SPECIAL
RADIO SERVICE
BULLETINS

THOMAS A EDISON, INC.
ORANGE N.J.

SPECIAL SERVICE BULLETIN FOR EDISON RADIO SERVICE ENGINEERS

CHANGE IN HUM ADJUSTER WIRING
TO ACCOMPANY
SERVICE BULLETIN #23

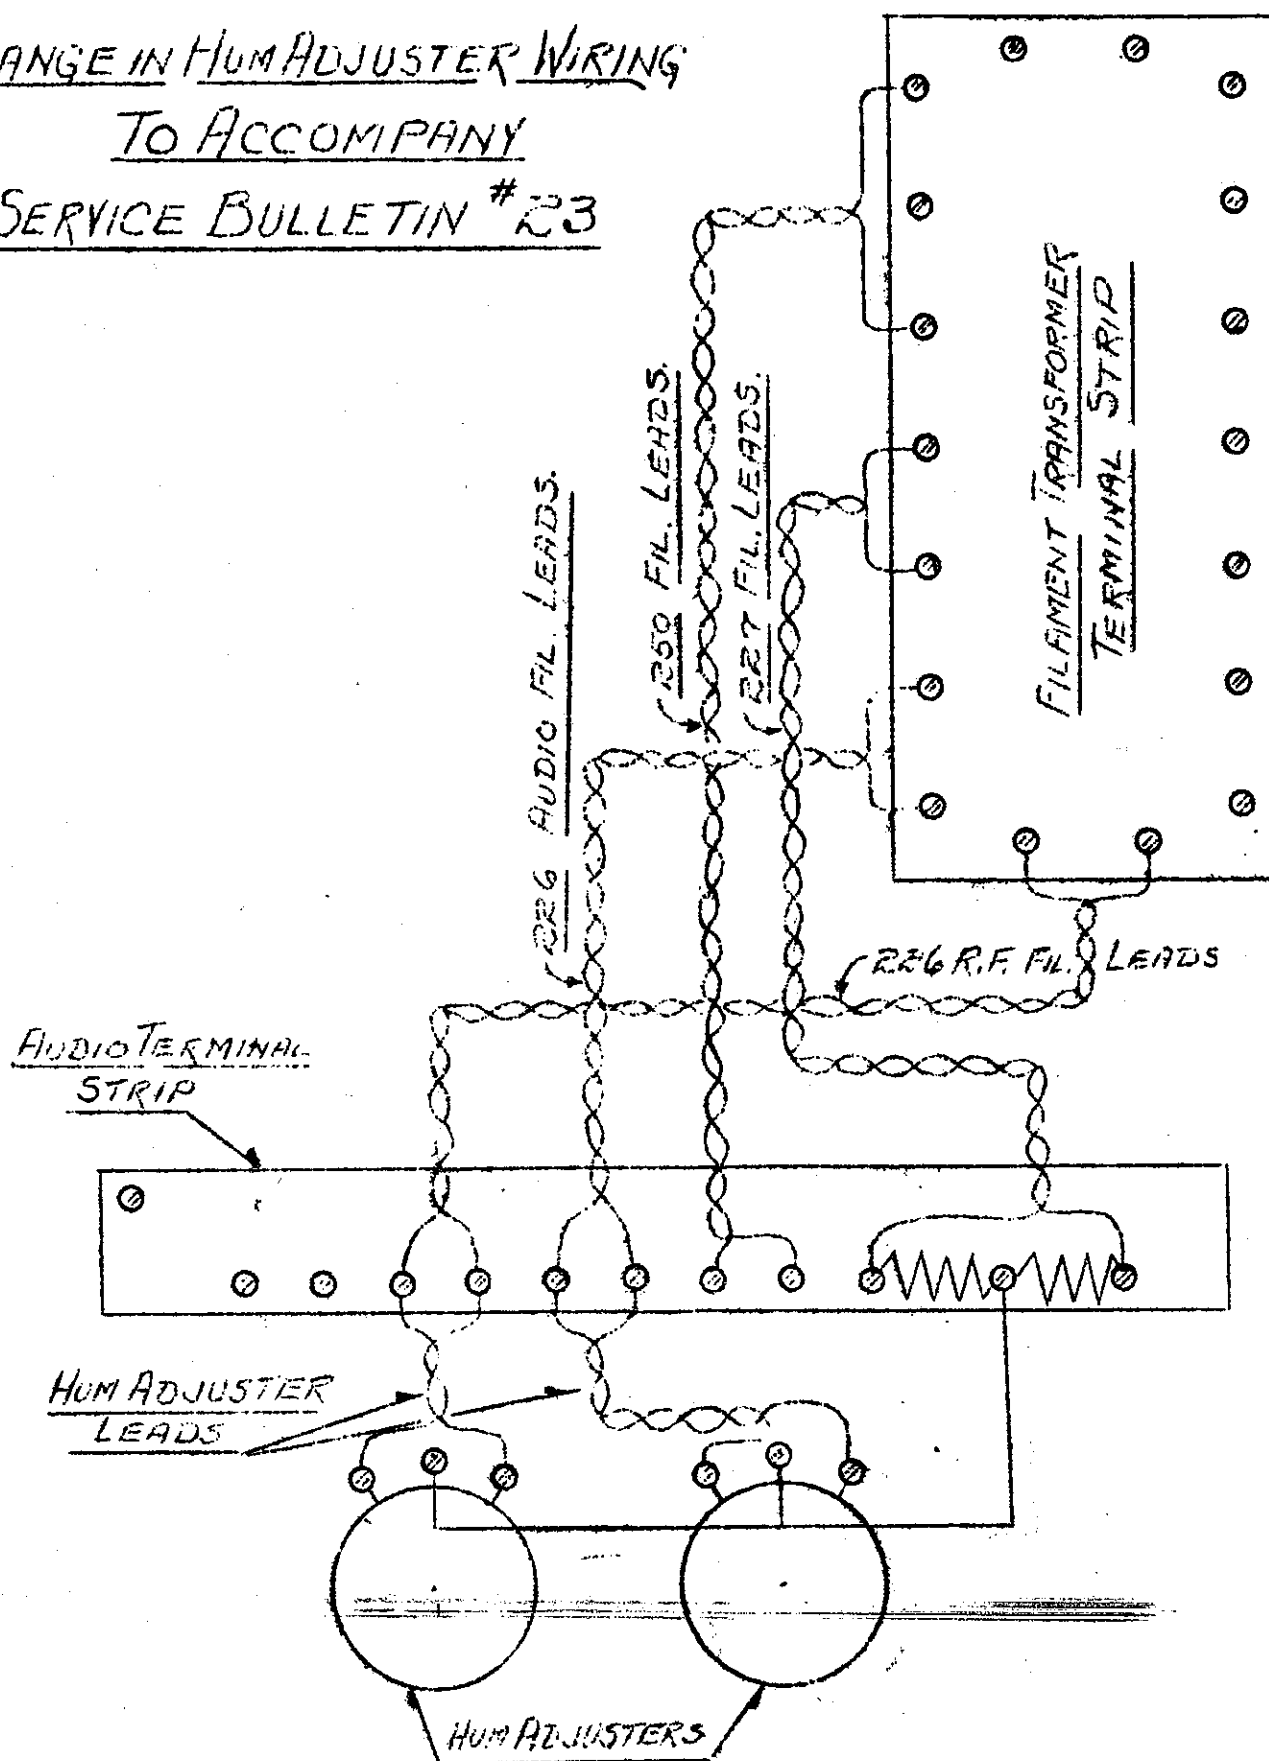
SUBJECT: "Proposed factory changes in chassis design
effecting J. R. and J. C. Models.

SHOWING CHANGE IN R.F. PRIM. COILS
TO ACCOMPANY BULLETIN # 24

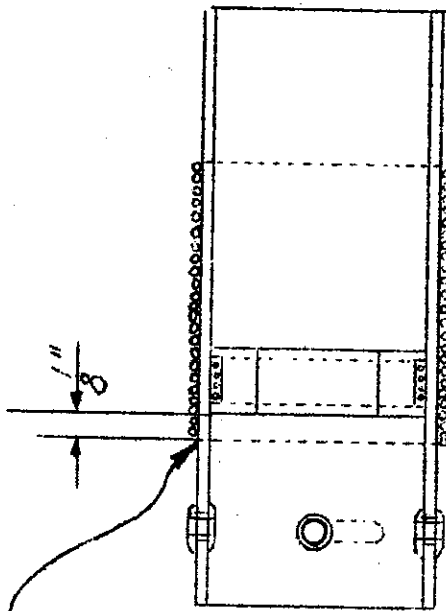
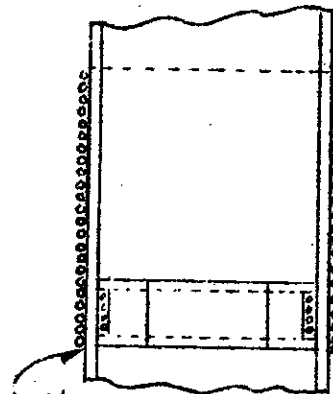
SUBJECT: "Change in Position of Radio Frequency Primary Coil to increase Selectivity in Poor Reception Areas".

1. If an Edison Set is located where the majority of stations are weak and the set has to be operated using regeneration at all times to get stations, it is advisable to change the position of the primary of each radio frequency coil as outlined in attached drawing.

2. To do this invert the chassis, remove the shield "holding clamps" and take off the cover of each shield. The primary spools are then in plain sight and by tapping them gently with a screw driver, they will break away from the amberoid cement that holds them in place. It is then an easy matter to push them 1/8" further into the secondary coil and fasten in place with amberoid cement. However, care must be taken so that none of the wires are broken. Shifting Primary coils results in greater signal strength on weak stations.

NOTE, BOTTOM OF PRIM.
COIL SHOULD BE $\frac{1}{8}$ " ABOVE
THE BOTTOM OF SECONDARY
WINDING AS SHOWN

NOTE, - BOTTOM OF PRIM COIL
SPOOL IS FLUSH WITH BOTTOM
OF SECONDARY WINDING.
